**APPENDIX L**

**Ohio EPA Comments**

**Subject: Ravenna Army Ammunition Plant, Portage/Trumbull Counties. "Comment Resolution on the Remedial Investigation/Feasibility Study Report" at RVAAP-06, C Block Quarry, Dated December 4, 2018.**

Subject: Ravenna Army Ammunition Plant (RVAAP) Restoration Program, Portage/Trumbull Counties, RVAAP-06 C Block Quarry, Comment Resolution on the Remedial Investigation/Feasibility Study Report (Work Activity No. 267-000-859-095)

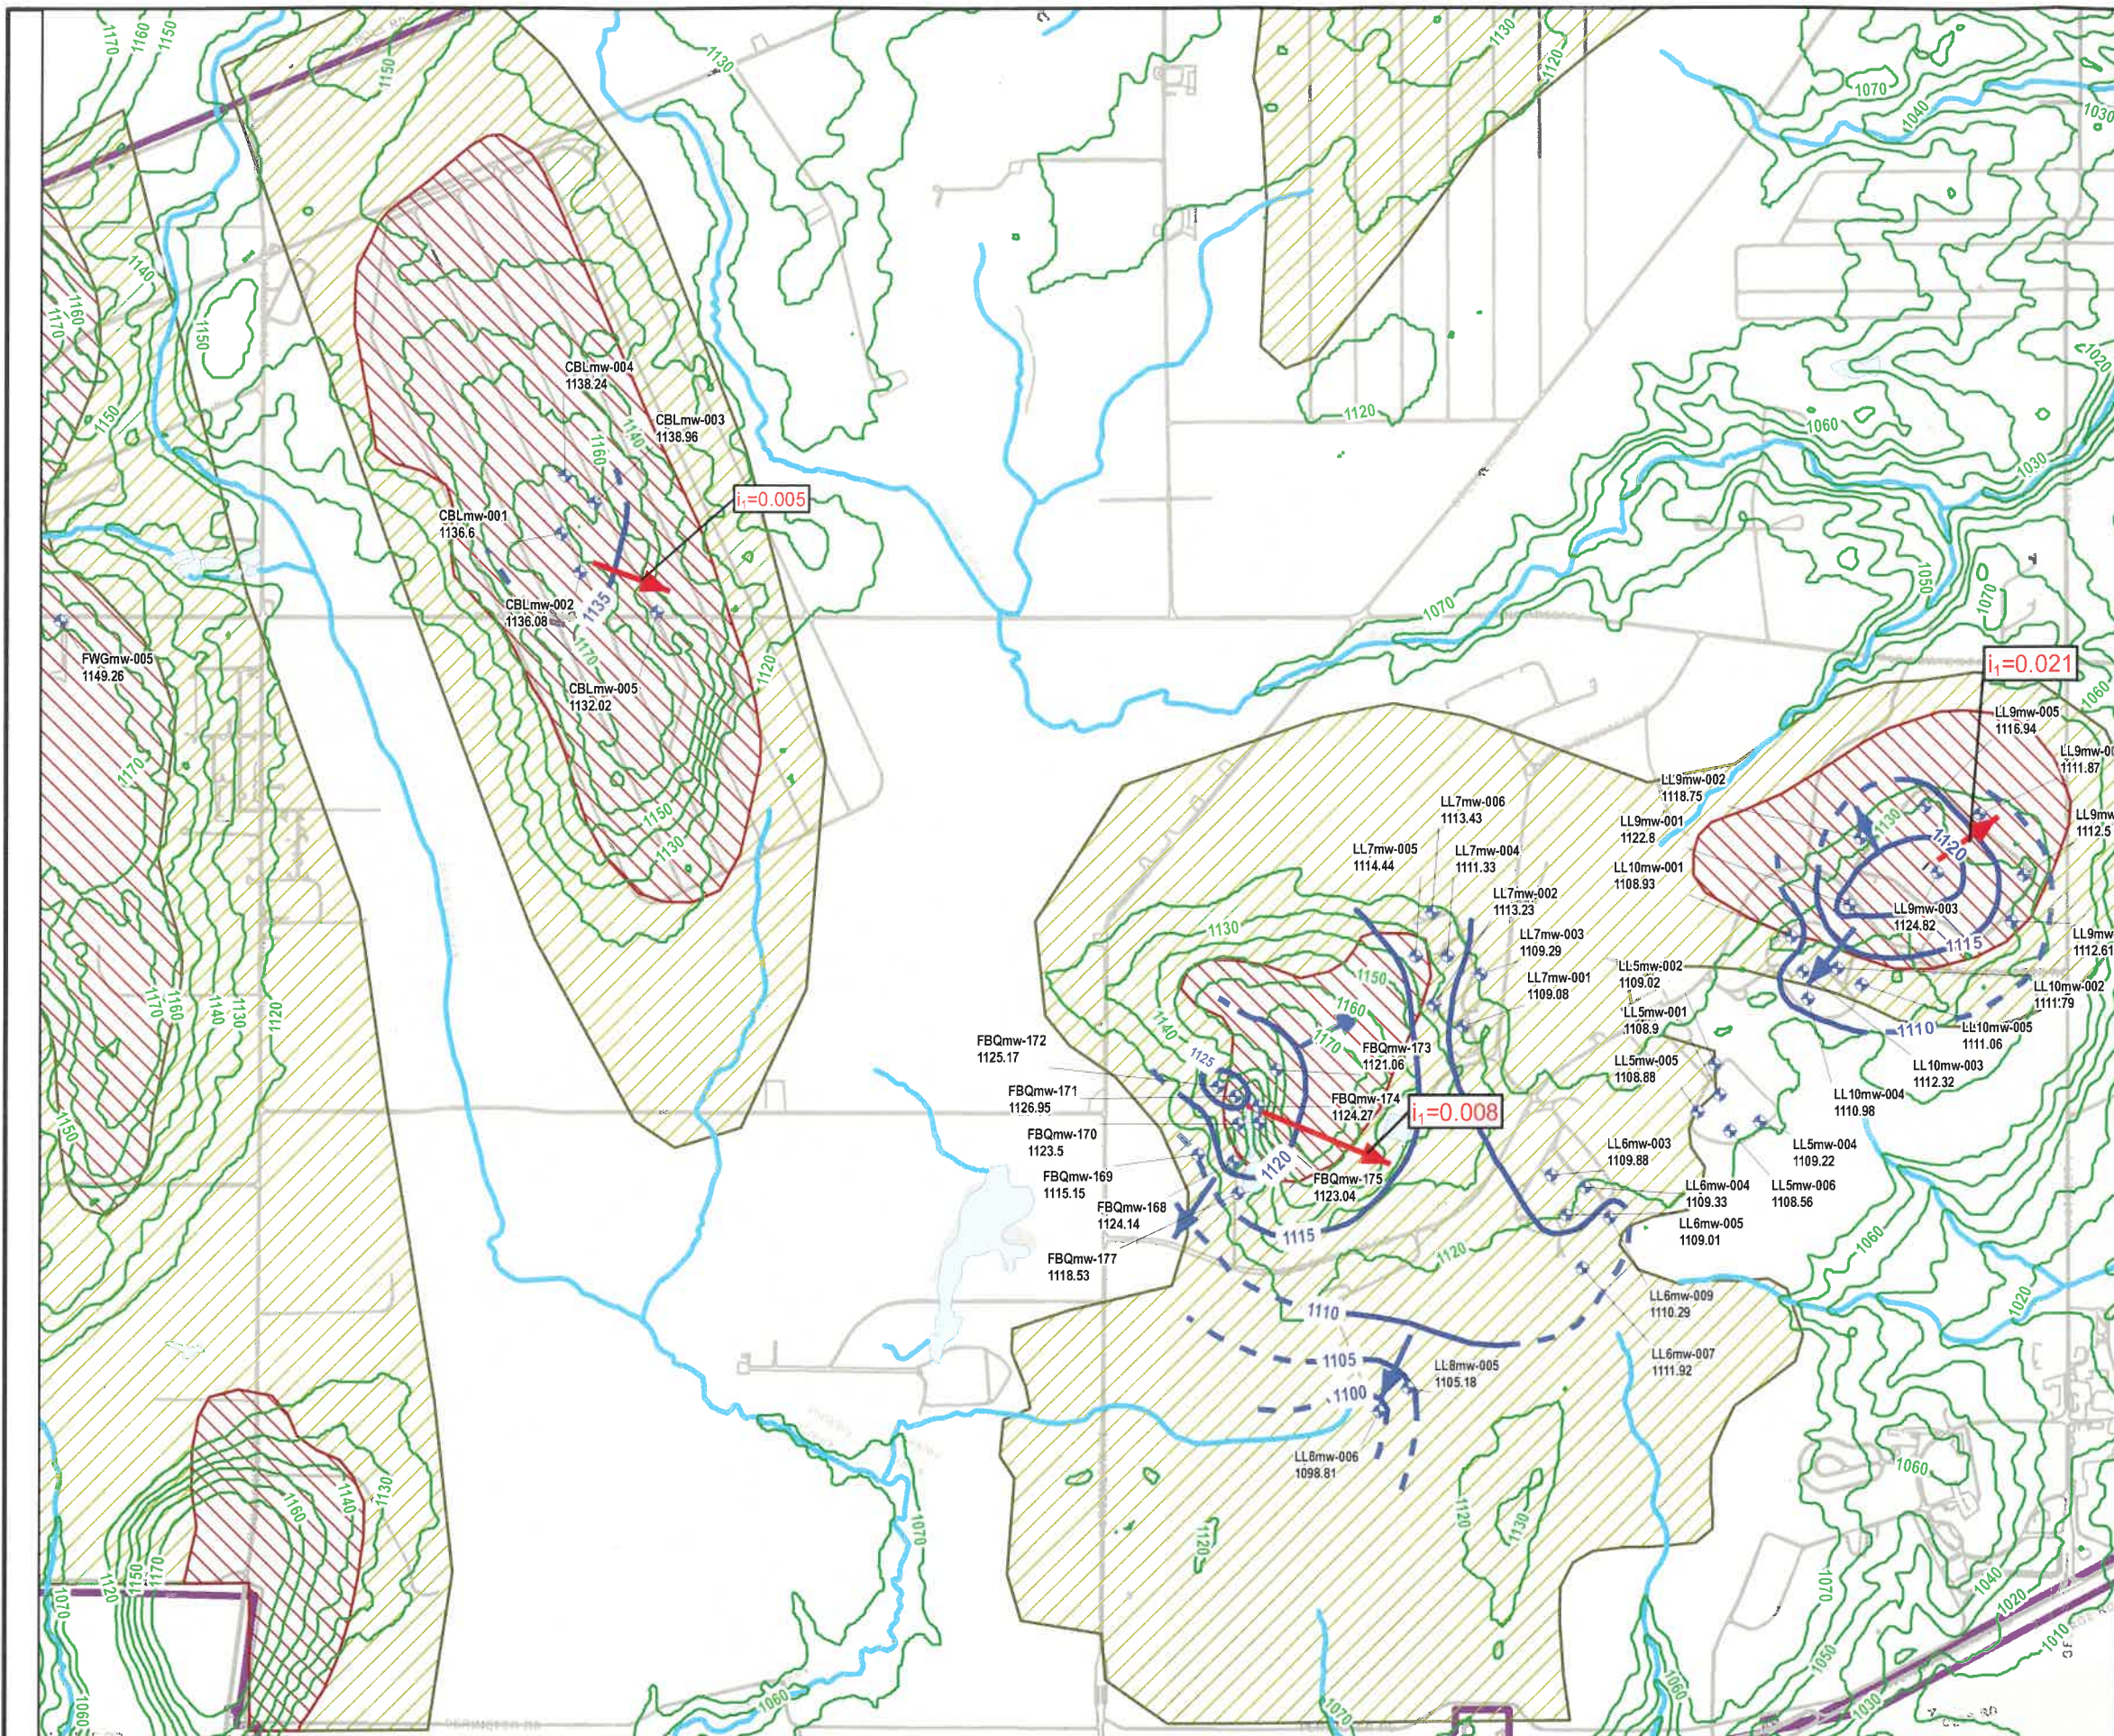
4. The Army's response to Ohio EPA's FTGW Comment 6 dated November 28, 2017, is inadequate. The ground water flow interpretations in Figures 3, 3-1, 4, and 4-1 are incorrect. Ground water flow on the knob of the Homewood Sandstone was re-interpreted a number of years ago to be radial, and not as shown on the figures. Attached is the most recent April 2017 Potentiometric Map, which shows radial flow in that hydrostratigraphic unit in the vicinity of C Block Quarry. While the aforementioned flow map only shows one flow arrow, the potentiometric map shows an arced potentiometric line, which follows the contour of the Homewood Knob in the vicinity C Block Quarry, where ground water flow in the Homewood is radial. Ground water flow interpretations in the RI report need to be modified to accurately show ground water flow in the vicinity of C Block Quarry.

4. The Army's response to Ohio EPA's FTGW Comment 6 dated November 28, 2017, is inadequate. The ground water flow interpretations in Figures 3, 3-1, 4, and 4-1 are incorrect. Ground water flow on the knob of the Homewood Sandstone was re-interpreted a number of years ago to be radial, and not as shown on the figures. Attached is the most recent April 2017 Potentiometric Map, which shows radial flow in that hydrostratigraphic unit in the vicinity of C Block Quarry. While the aforementioned flow map only shows one flow arrow, the potentiometric map shows an arced potentiometric line, which follows the contour of the Homewood Knob in the vicinity C Block Quarry, where ground water flow in the Homewood is radial. Ground water flow interpretations in the RI report need to be modified to accurately show ground water flow in the vicinity of C Block Quarry.

The groundwater flow interpretations on Figures 3-1, 4-1, and all other applicable figures have been revised to reflect the groundwater elevations collected in April 2017 and the potentiometric map presented in the FWGWMP Annual Report for 2017. Revised Figure 3-1 is presented as an attachment to this response letter.
